UNITED STATES
DEPARTMENT OF THE INTERIOR
BUREAU OF LAND MANAGEMENTFORM APPROVED
OMB No 1004-0135
Expires January 31, 2004**HOBBS****SUNDRY NOTICES AND REPORTS ON WELLS**Do not use this form for proposals to drill or re enter an
abandoned well. Use Form 3160-3 (APD) for such proposals.

Cactus Queen Unit #10

Yates Drilling Company
Cactus Queen Unit #10
Unit L, Section 34-12S-31E
Chaves County, NM
30-005-20880
Sundry attachment
April 8, 2009

Permanent Abandonment of Federal Wells Conditions of Approval

CACTUS QUEEN UNIT #10

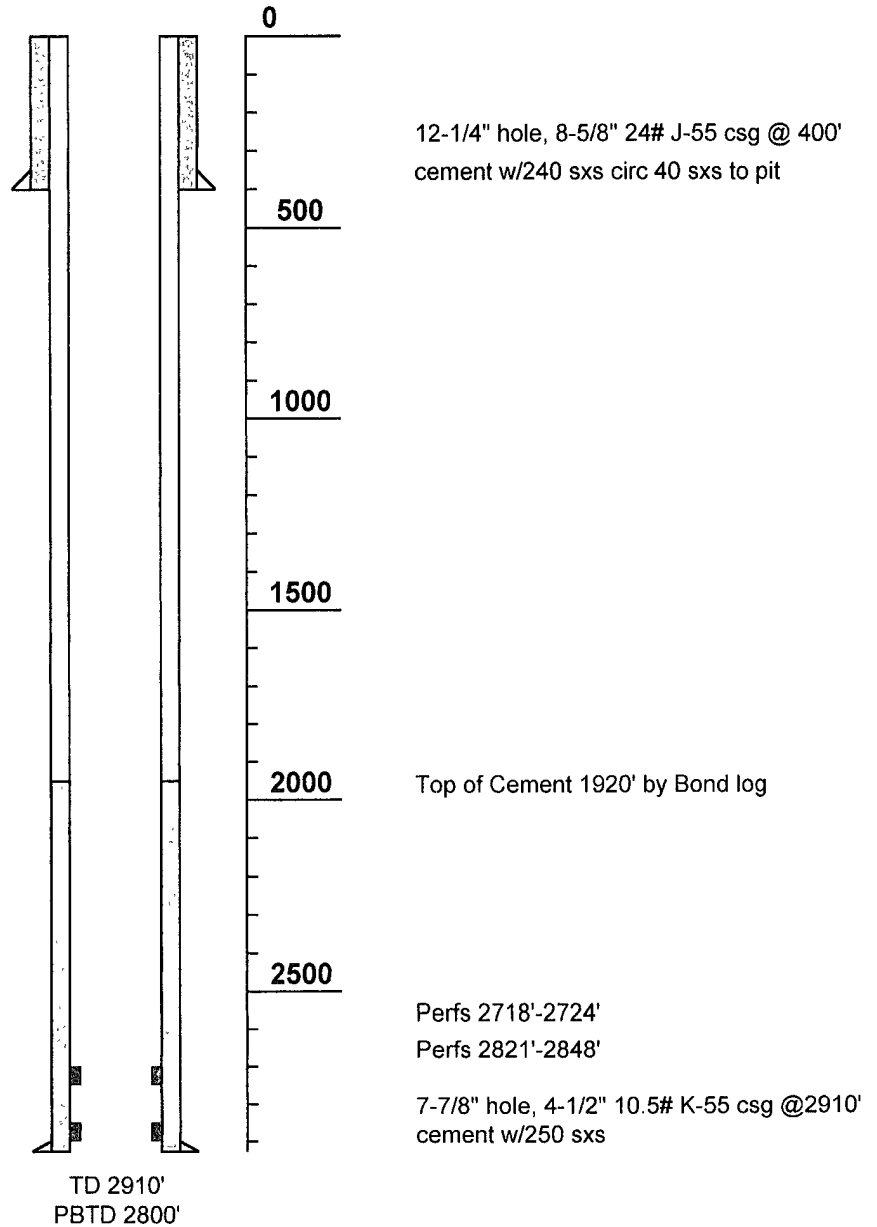
- 1. Set CIBP @ 2,700', mix and circulate 10# mud inside 5 1/2" casing to surface
- * ~~2. Spot 25 sxs Class "C" cement plug on top of CIBP~~
- 3. Perforate 5 1/2" casing @ 1,100', TOS
- 4. Set packer @ 1,050'. Mix and pump 10# mud, establish rate and circulate to surface out 5 1/2" annulus.
- 5. Set cement retainer @ 1050'. Mix Class "C" cement & pump cement to surface out 5 1/2" annulus. *+ 5 sxs. cnt. on top of CIBP.*
- 6. Pump cement plug in 5 1/2" casing 450' to surface
- 7. Erect dry hole marker, remove all equipment and clean location.

* Perf. @ 1890', squeeze w/ MINIMUM 25 sxs. cnt.
WOC + TAG
